**Planning & Zoning Commission
Tuesday, May 20, 2025, 6:00 PM
Public Meeting Room / Eagle Town Hall
200 Broadway, Eagle, CO 81631**

1. Project: DR25-02 ANB Bank Minor Development Permit
File # DR25-02
Applicant: ANB Bank, c/o Alder Real Estate, Will Coffield
Location 295 Eby Creek Road
Staff Contact: Sydney Dynek, Planner
Request: A Minor Development Permit to construct a 3768 square-foot commercial building.

TO: Planning & Zoning Commission

Title:
LANDSCAPE LAYOUT
PLAN

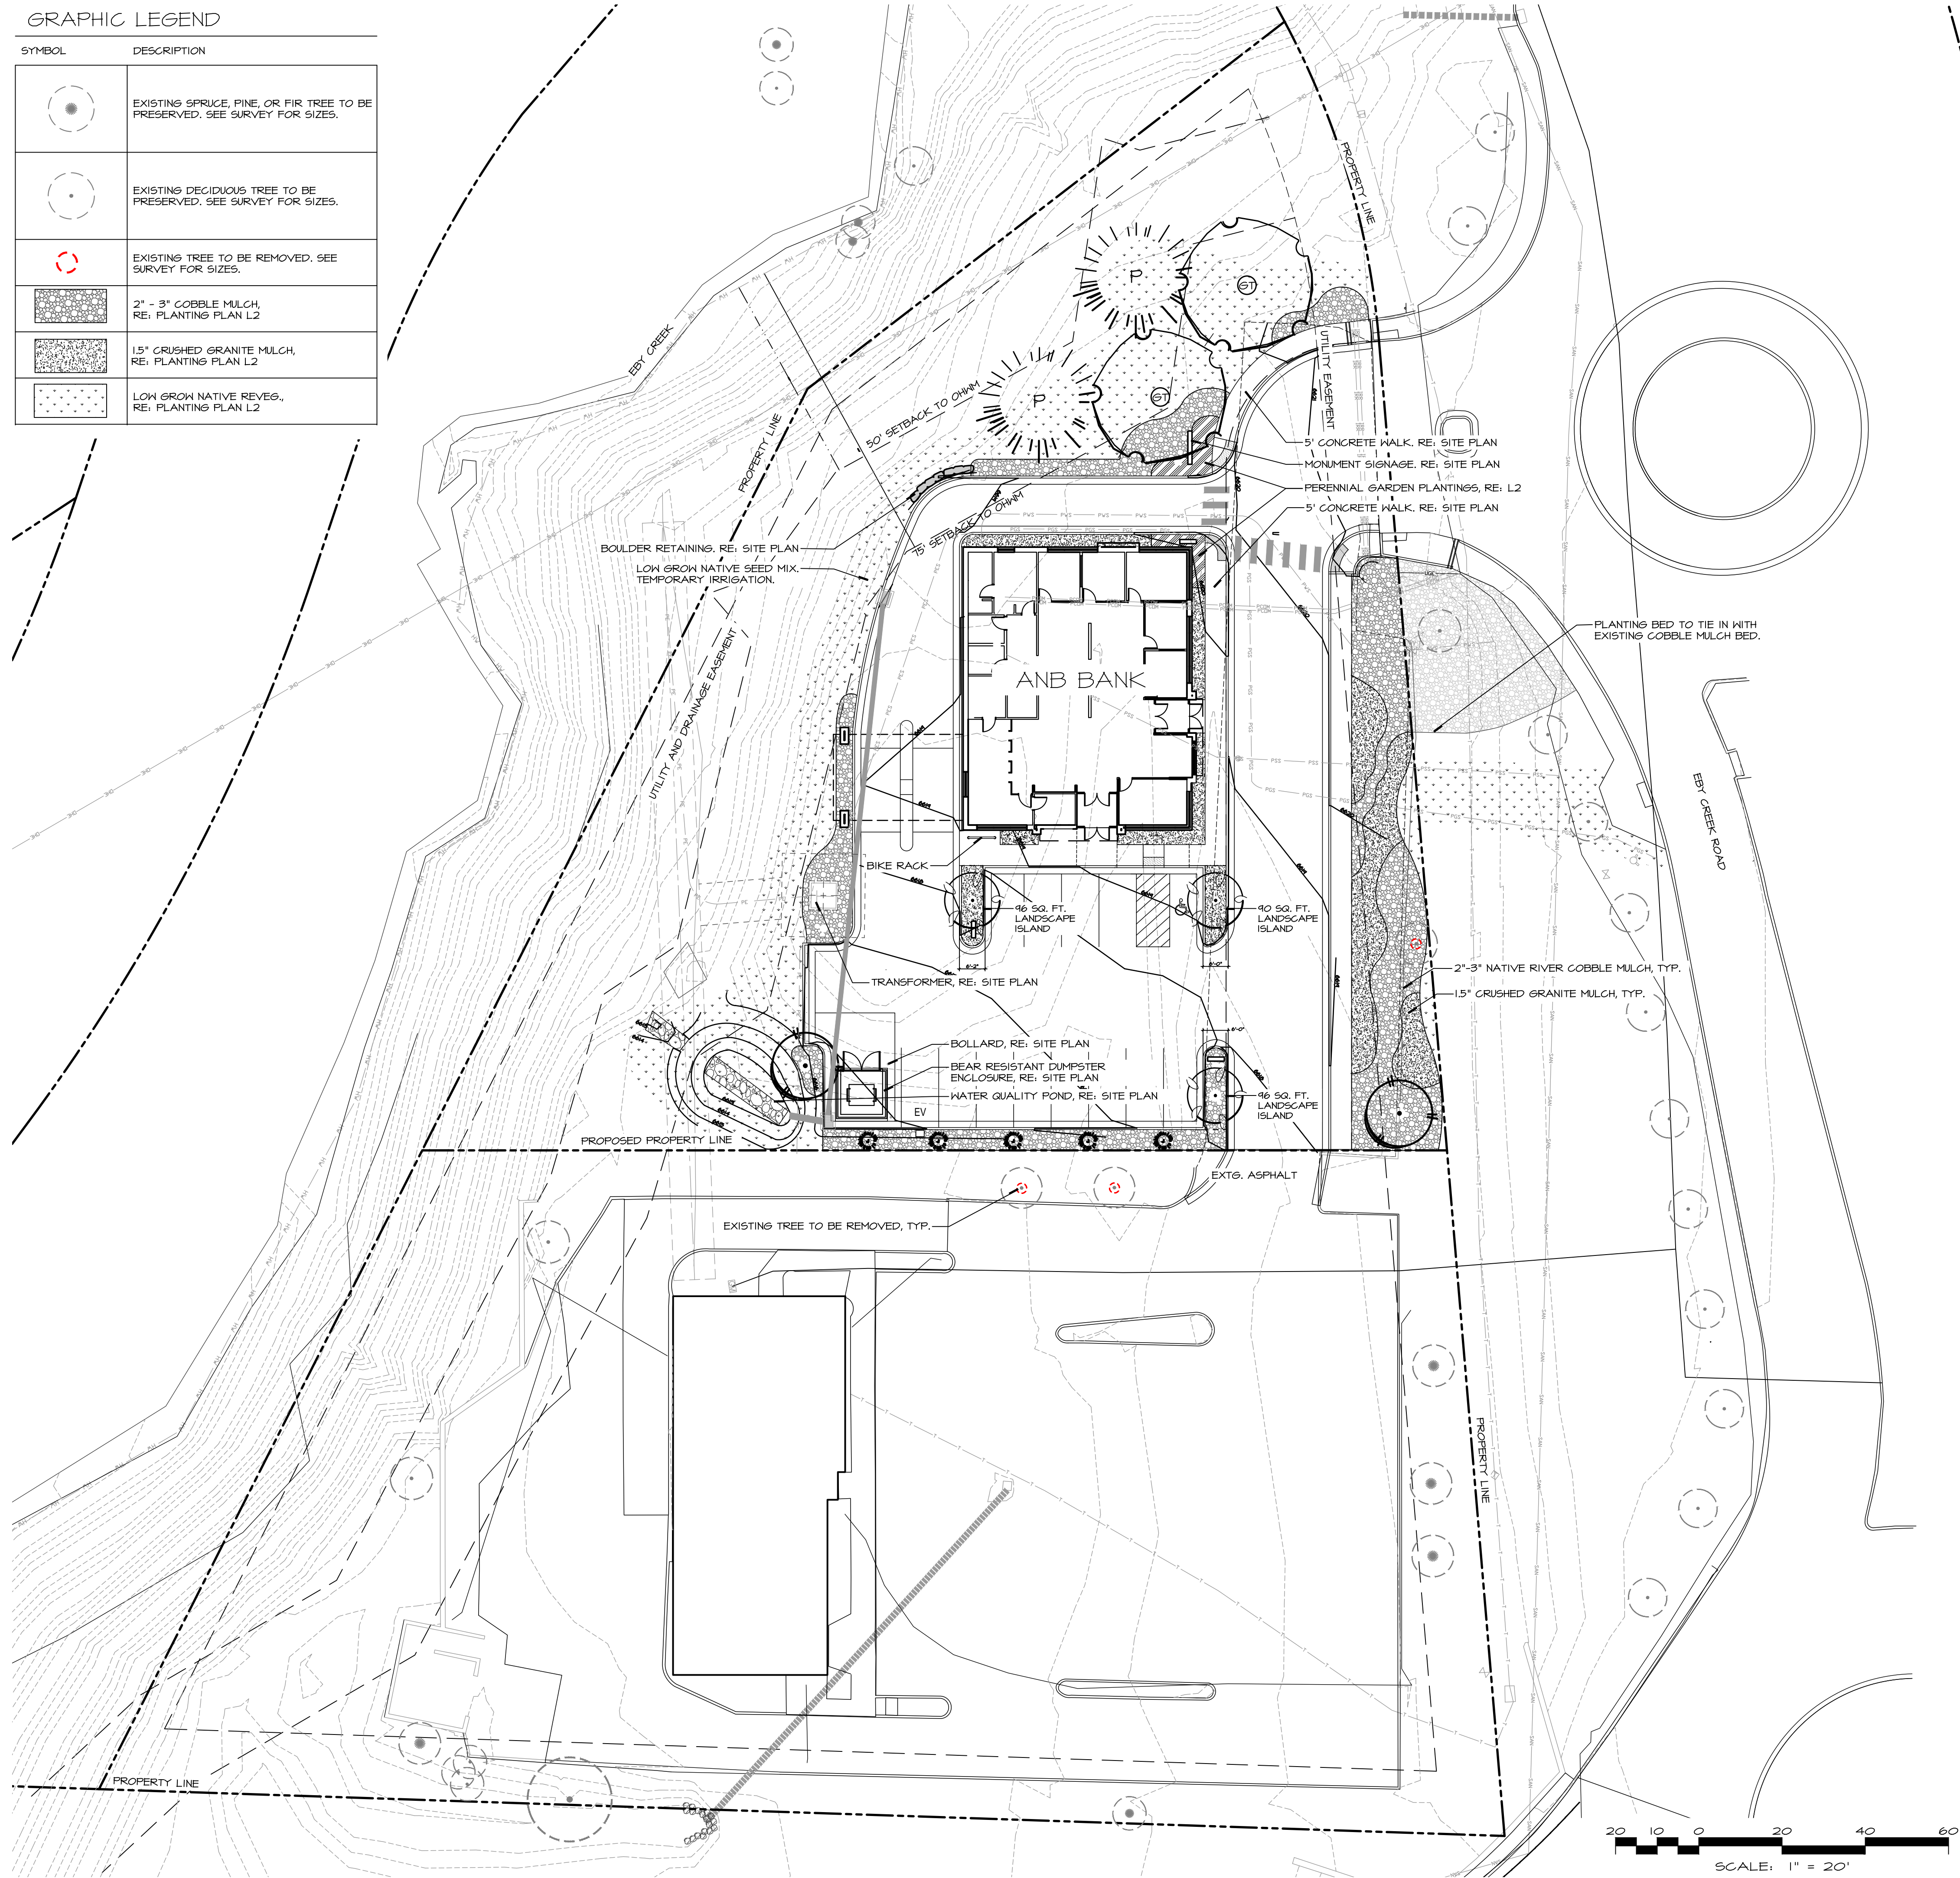
Staff Comment: A landscape plan for the proposed development was provided on page L2 of the set. The provided plans include a legend detailing all the proposed plant materials and indicating their drought tolerance. An irrigation plan was provided on L4 of the plan set that included the methodology for irrigating the required parking lot landscaping. This plan denotes which existing trees on the property will be left and which will be removed to accommodate the proposed development. Ground surfaces and material types were indicated on the provided landscape plan, along with the percentage of drought tolerant plants, on sheet L2. All the Greenmound Currant shrubs indicated on the plans are the male cultivar that don't produce fruit. All of the proposed plant materials except for the viburnum and the spirea are drought tolerant and low-water using. No turf grass is included in the proposal and the proposed trees and shrubs meet the minimum plant size specifications. Three landscape islands as required per Section 4.11.050 are included in the design, with each island including a hawthorn tree, some shrubs, and river cobble or crushed granite mulch.

Title:
PLANTING PLAN

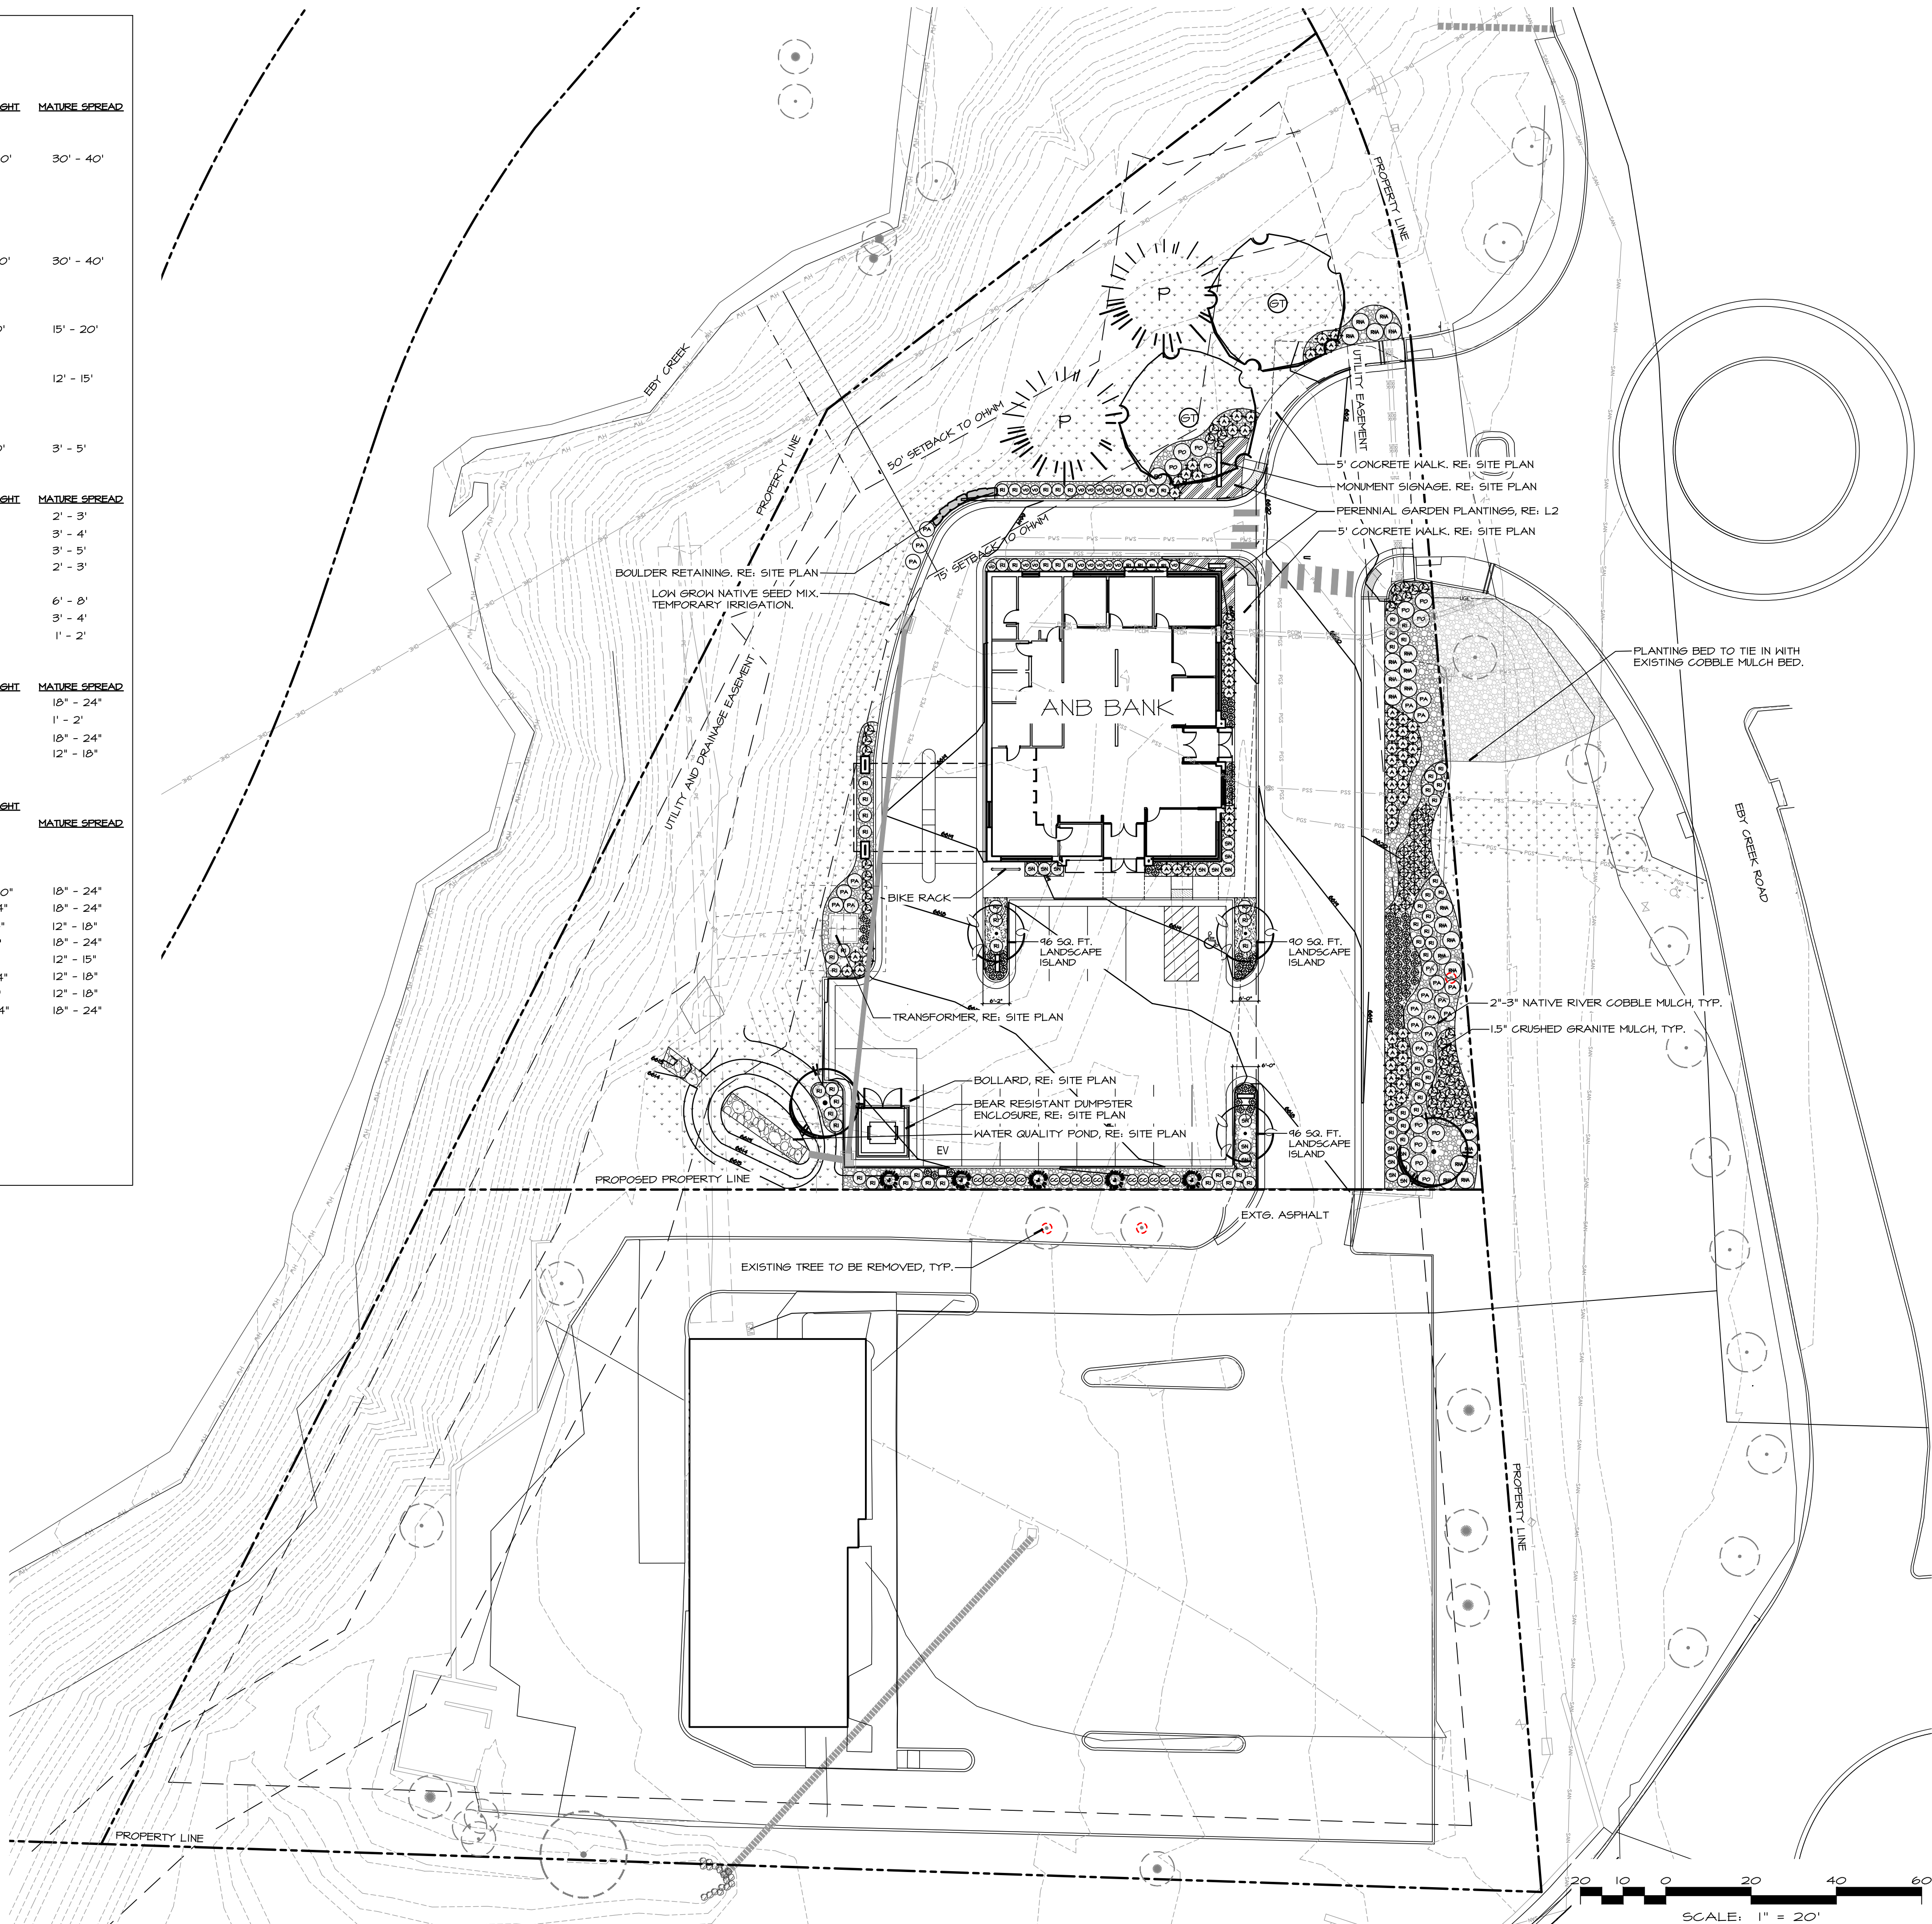
Within the provided landscape plan, the front yard landscape buffer is 11 feet wide at the narrowest point adjacent to Eby Creek Road. The required landscape areas reflect the existing vegetation communities on adjacent properties with a minimum of 50% of the required street frontage landscape areas covered in cultivated landscaping. All the proposed ground cover consists of low-water, drought-tolerant plants. The proposed landscape plan currently depicts one Hot Wings Maple tree in the southeast corner of the property and there are no other trees proposed in the front yard buffer. As a condition of approval, additional trees will need to be added to meet the standard requiring one tree per 25 linear feet. An interpretation has been made to allow for this standard to be met through averaging if the applicant chooses to clump the trees to meet this standard.

5. The applicant shall add trees to the front yard buffer in the landscape plan to demonstrate compliance with the front yard buffer standards prior to building permit application.
